AMENDMENT OF SOLICITATION/MODIFICATION OF CONTRACT

A. The Solicitation Number cited above, NZP-DC: Construct Arabian Leopard Exhibit, located in Washington, DC, is hereby amended as follows:

A.1. Attached hereto and made part of this Amendment Six are the SI Responses to RFI's for Questions Number 227-552.

PN 2533105 RENEW ARABIAN LEOPARD FACILITY: PHASE 2 HABITATS & ANIMAL CARE BUILDING TECHNICAL & PRICING PACKAGES - REQUESTS FOR INFORMATION (RFI)					
RFI No.	**Reference / Source**	**Question**	**Response**	**Date In**	**Date Out**
1	RFP, SF 1442 Continuation Sheet (Optional Form 336) Pages 3 & 4 of 139	I know that RFIs are due on 9/30 but considering we only have the 65% design set of documents, will there be another opportunity for RFIs once the 100% bid docs are released in October? Any feedback you can give me on this will be appreciated.	The 100% Final bid documents are forthcoming via an amendment, anticipated to be issued on October 13, 2026 due to 10/12/25 being a federal holiday. A second, two-week period for pre-bid RFIs has been accounted for in the procurement schedule and will take place from 10/12/26 thru 10/23/26. However, as noted in the SF 1442 request for pro

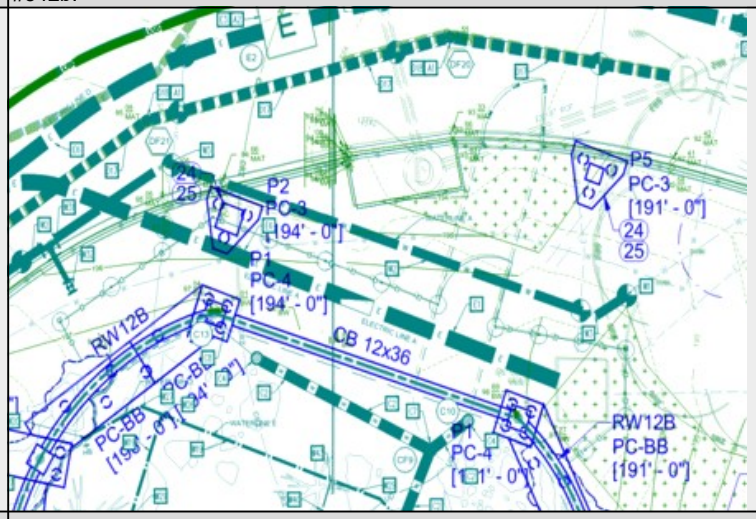
395	Spec 084400	Preconstruction testing on glazed curtain wall 084400 gives 3 different test types (on-building, off-building, preconstruction laboratory mockup), please confirm if all 3 of these are required for the project	Specification section 084400 1.9 Mockups denotes the applicable Mockups where preconstruction testing shall be applied.	10/30/2026	11/9/2026
396	Architectural	Please clarify what the required dimensions are for the laboratory mockups for storefront and curtainwall?	Laboratory mockups are not necessary for this project.	10/30/2026	11/9/2026
